AMENDMENT OF SOLICITATION/MODIFICATION OF CONTRACT			1. Contract Number	Page of Pages 1 7	
2. Amendment/Modification Number DCAM-2007-B-0072-0001	3. Effective Date 30-Apr-07	4. Requisition/Purchase Request No.		5. Solicitation Caption Replace Lighting System @ 4D

14. Description of amendment/modification.					
This Addendum No. 1 is being issued for the following:					
1. The Bid Opening Date has been postponed until Tuesday, May 8, 2007 at 2:00 p.m.

The following responses are answers to questions raised by potential bidders during the past several weeks. These responses are to be considered as additions/clarifications to the bid document package for the Replacement of the Lighting Alert System for the Antenna Tower at the 4th District Police Headquarters.

ZONING DOCUMENTS
4D / HUGHES TOWER
6001 GEORGIA AVENUE, NW
WASHINGTON, D.C. 20011

**ZONING DOCUMENTS
ELEVATION**

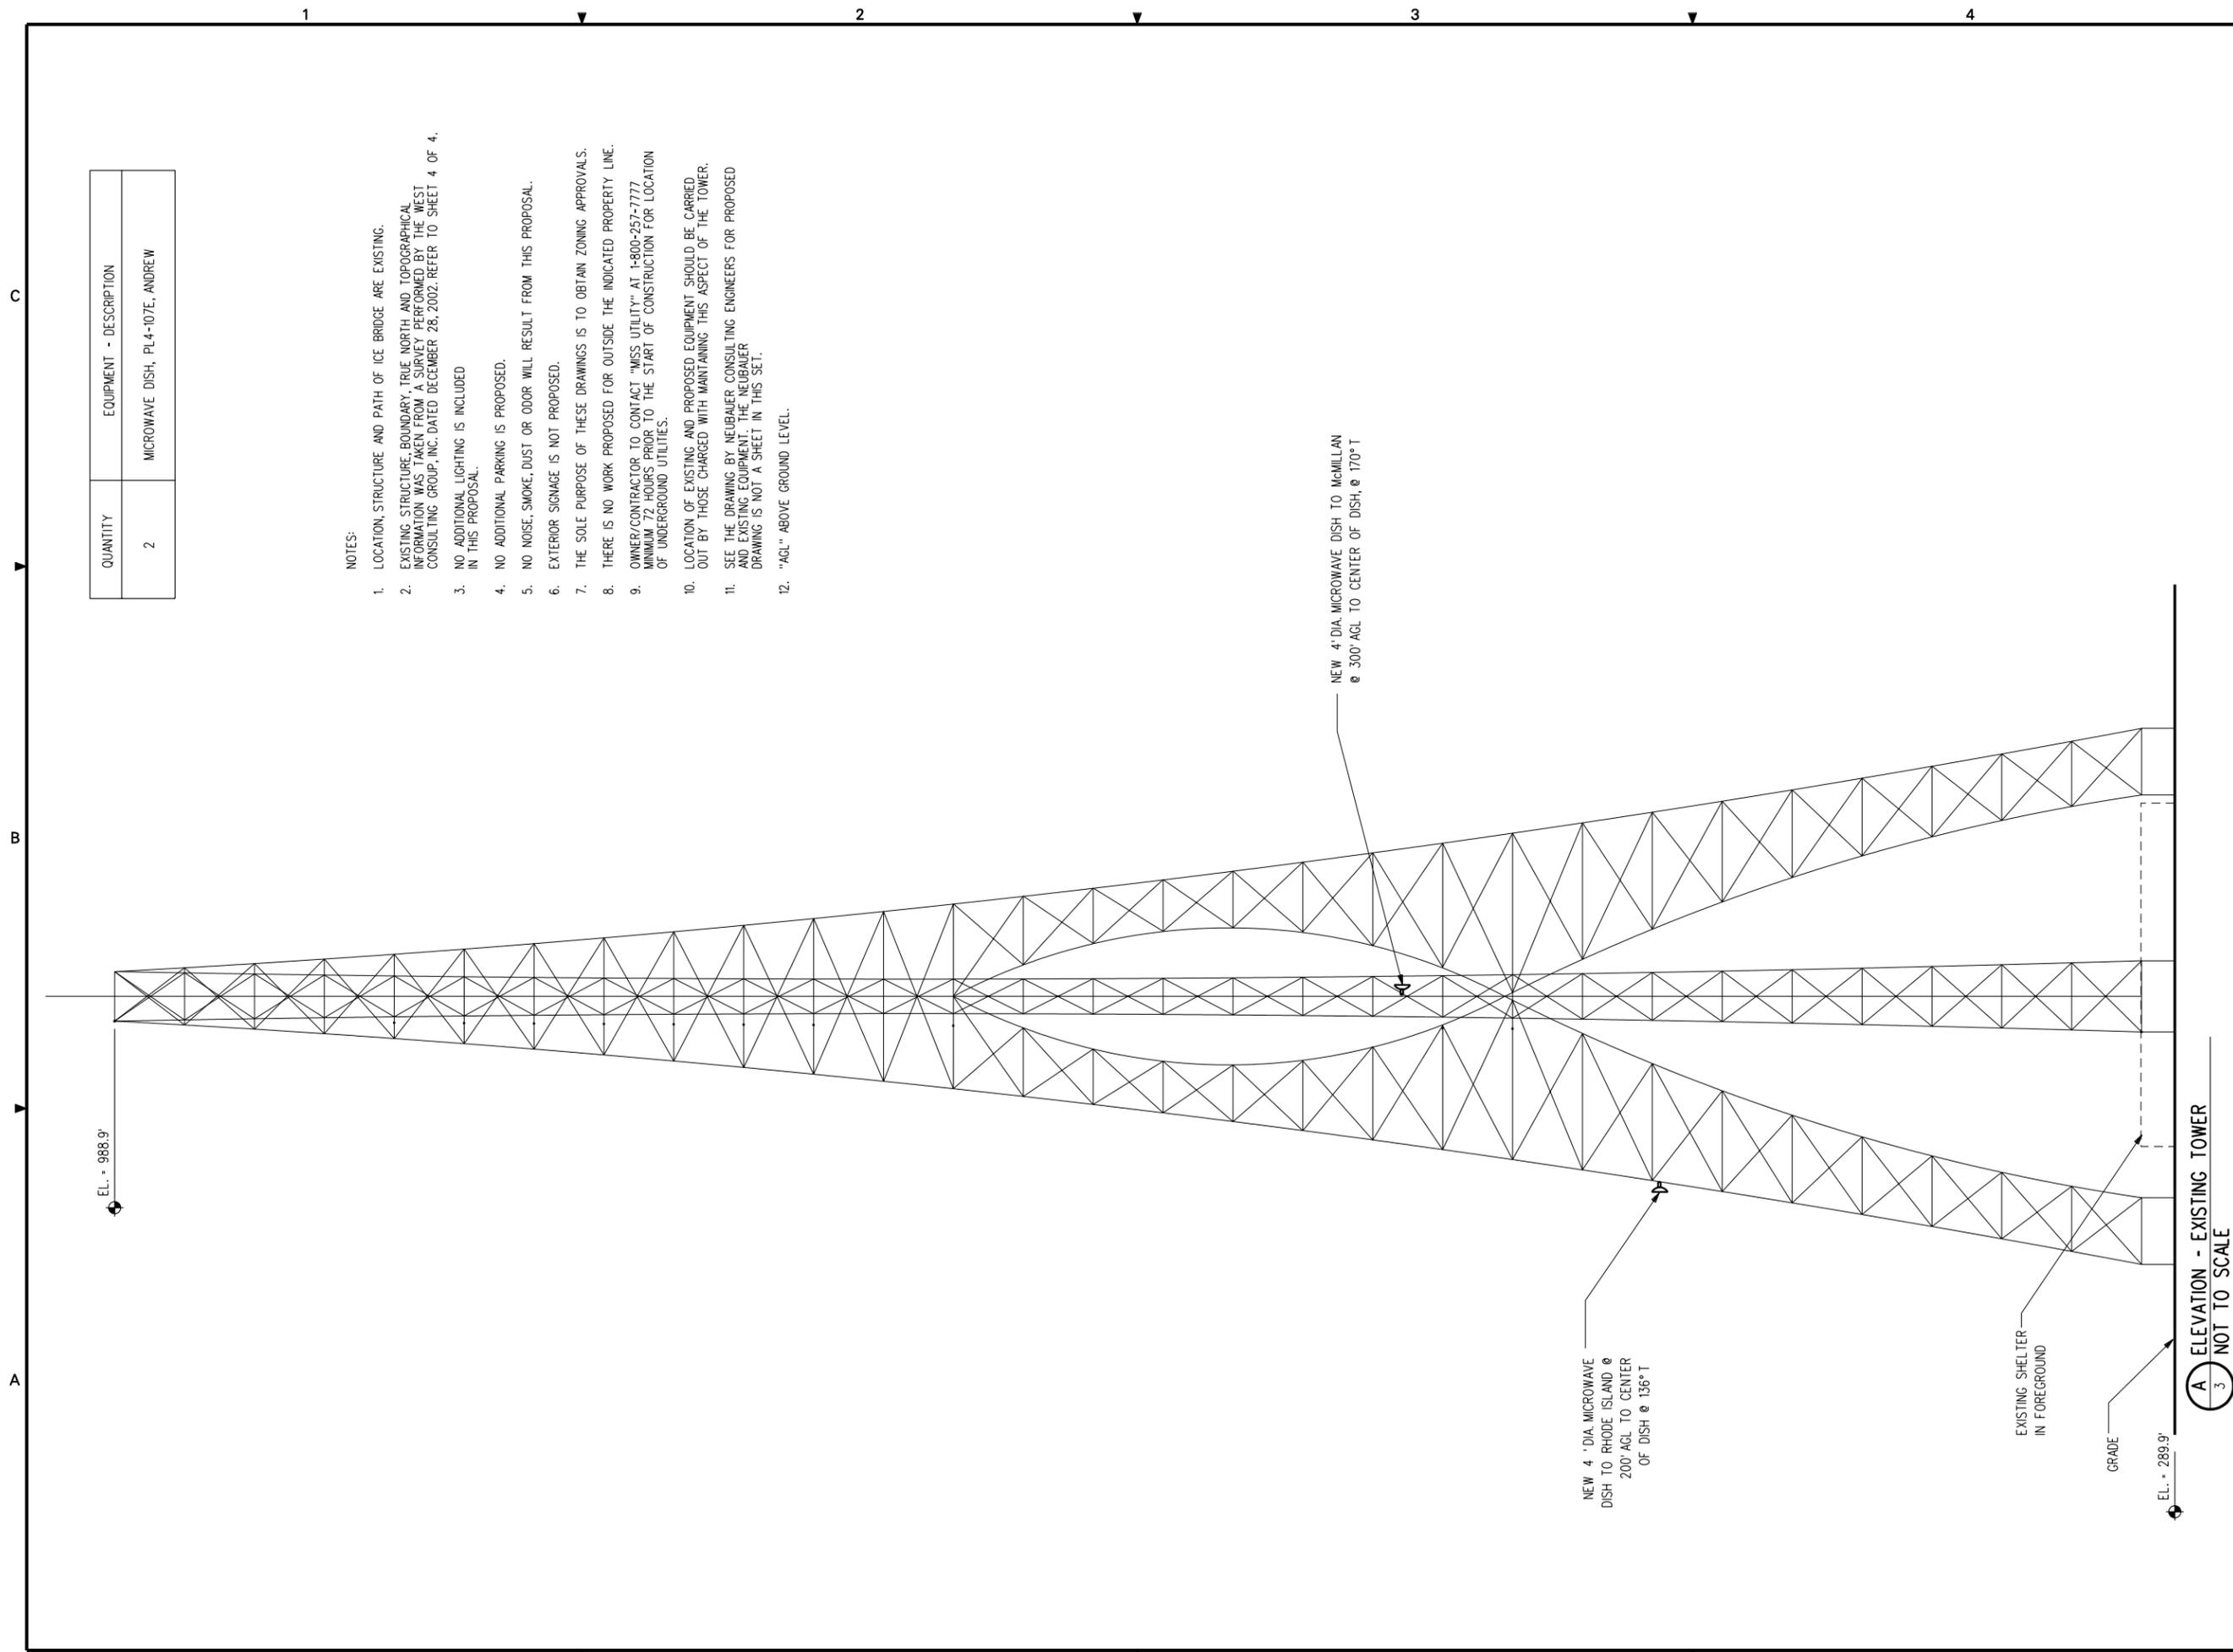
3. What is the exact height of the tower?

Answer: See attached drawing for exact height of the tower.
